Suite 403/404 - ORIGINAL LAYOUT

CONSTRUCTION SUMMARY

Hampton Place

| LOT NUMBER | PHASE | HOUSE TYPE | CLOSING DATE |
|------------|-------|------------|--------------|
| 403+404    | 1     | MAIDSTONE  | 09-Oct-18    |

[KITCHEN] = SEE TOWN  
MY OUT W

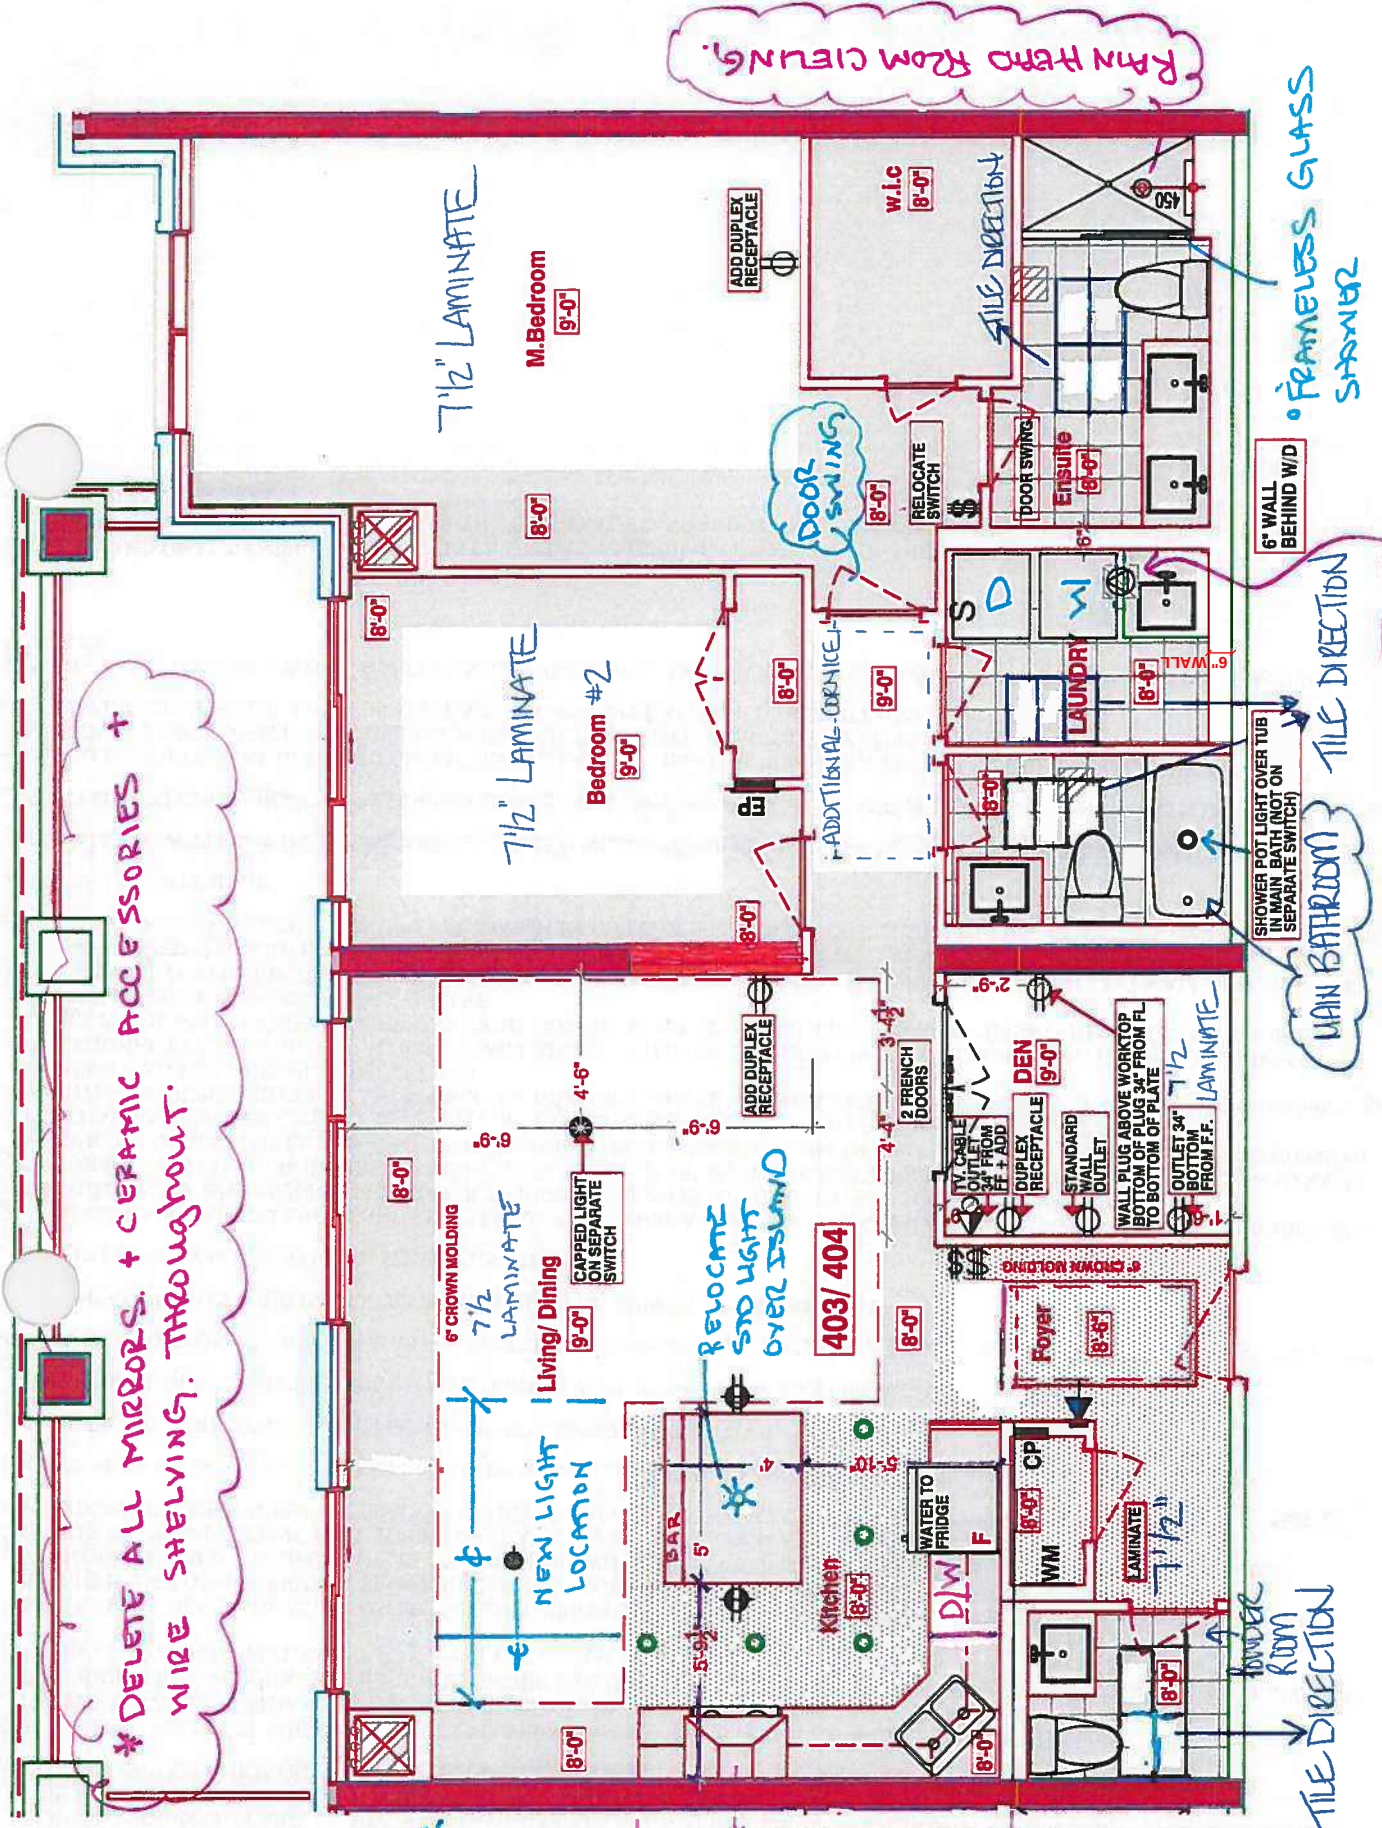
- UPG #2 - APPLIANCE PKG W SPECIAL FRIDGE
- (x6) = PUCK LIGHTS
- (x2) = PLUGS ISLAND
- (x1) = RELOCATE STD LIGHT OVER ISLAND
- ISLAND SEPARATE SWITCH (STD)
- (x5) POTS IN KITCHEN (SEP. SWITCH)
- ISLAND WIRING FOR MICO + WINE COOLER
- REVISED DROP IN KITCHEN DUE TO EXTENDED KITCHEN
- ISLAND MOVED TOWARDS LIVING ROOM.
- DELETE STD BACKSPASH

• POWDER ROOM + MMW + ENSUITE RAISED 36 1/4" VANITIES + DELETE 3" SPLASH

• LAUNDRY VANITY RAISED 36 1/4" W STD TOL MOUNT SINK + STD FAUCET.

| CLIENT: ROYAL PINE HOMES |               | JOB NAME: UNIT 403-404 HMP |     | ROOM: KITCHEN BULKHEAD PLAN |     | DRAWN BY: SK |                |

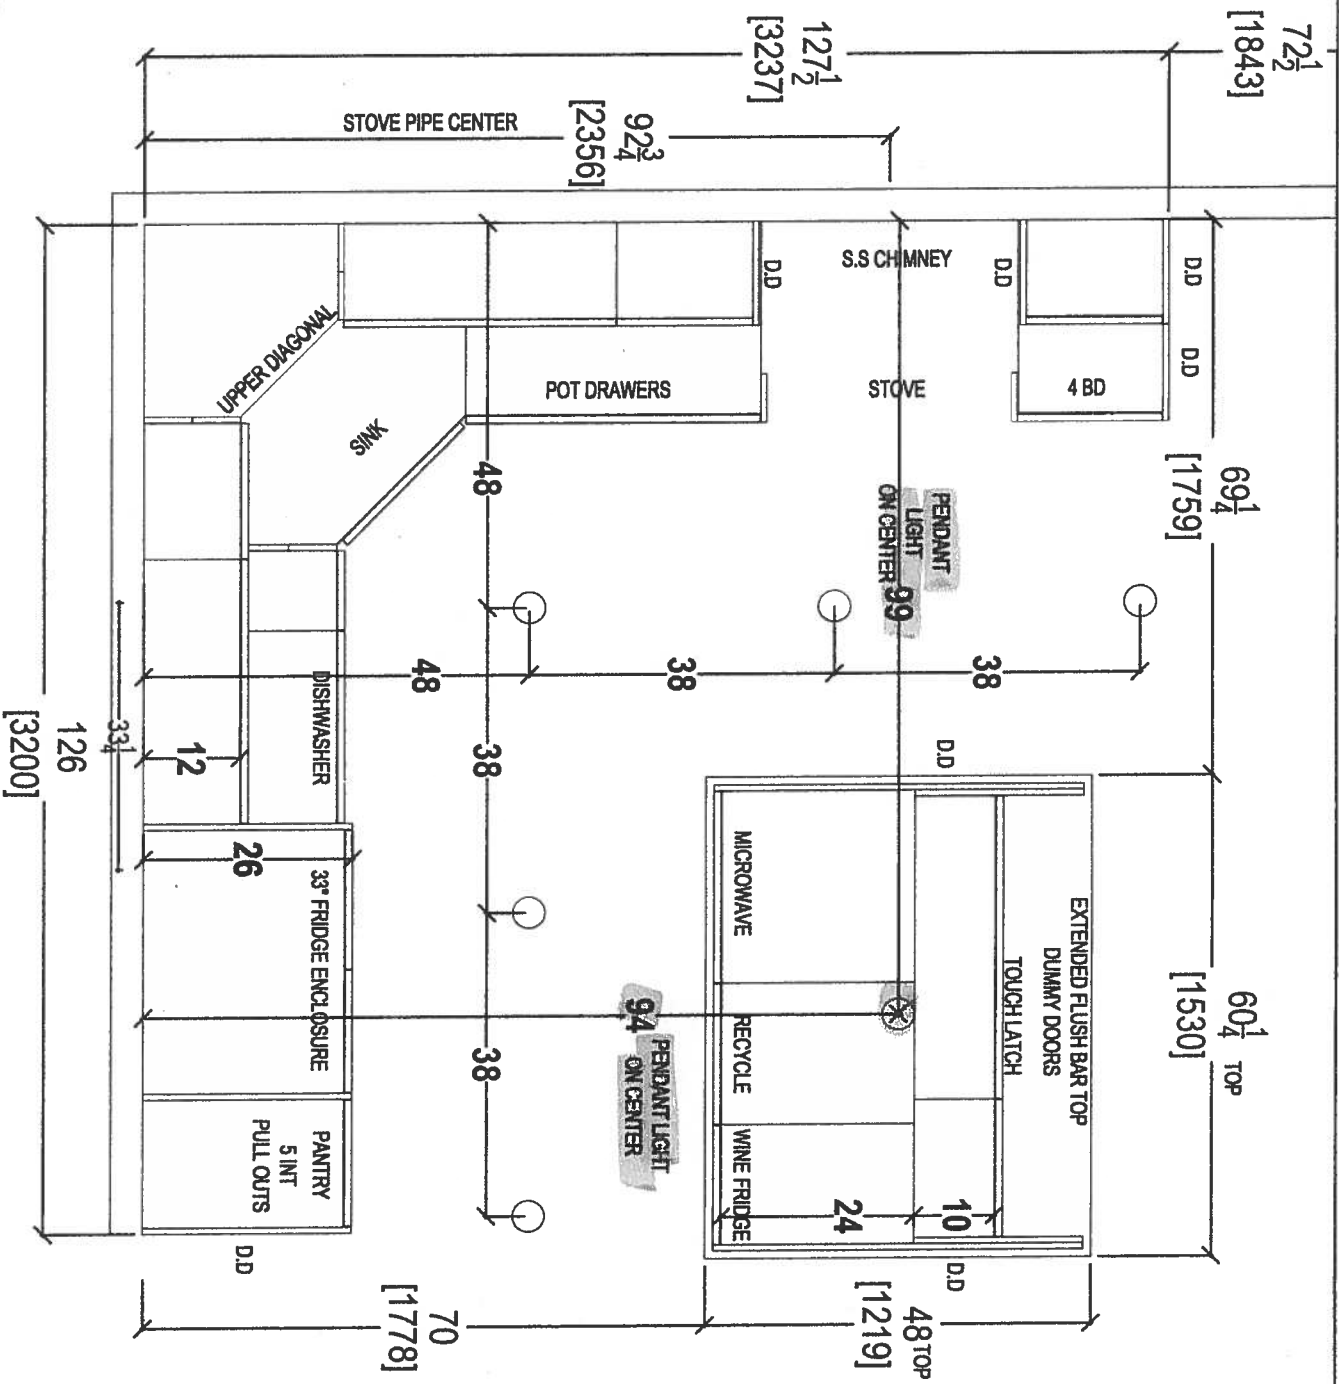
1 - KITCHEN- Install an additional 15" of dropped ceiling in the kitchen area.  
Shift the Dining Rm Ceiling light towards the patio sliders to accommodate the increased dropped ceiling  
lights to be shifted and adjsuted accordingly- Refer to QTK sketch  
Approved by Vince  
No charge as per Steve C

| CLIENT: ROYAL PINE HOMES | JOB NAME: UNIT 403-404 HMP | ROOM: VANITIES   | DRAWN BY: SK         | COMMENTS:                                                                                           |

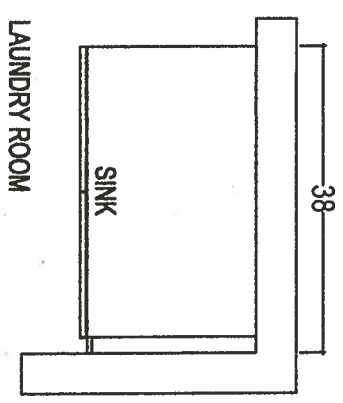
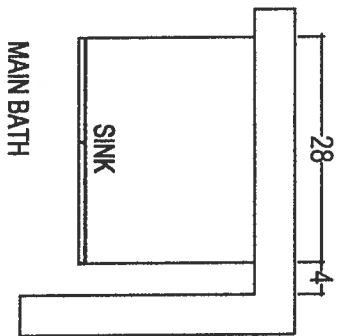
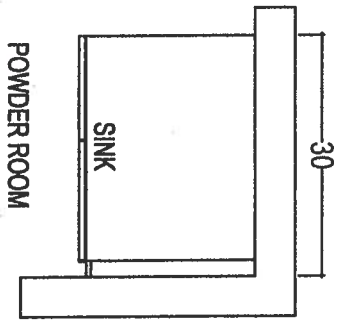
\* RAISED VANITY \*  
STD TOP MOUNT SINK  
+ STD FAUCET

\* RAISED VANITY \*  
DELETE 3" SPLASH

\* RAISED VANITY \*  
DELETE 3" SPLASH

Delta Shower Trim ~~XXXXXX~~ and  
Hansgrohe Slide Bar with Handheld and  
CEILING ~~110~~ Mount Showerhead  
#R10000/T13020-CDN/27454002/  
27744000/RP52382/RP46870/RP6025/  
R11000/T11800

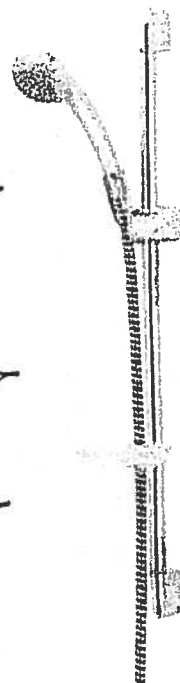
FROM  
CEILING
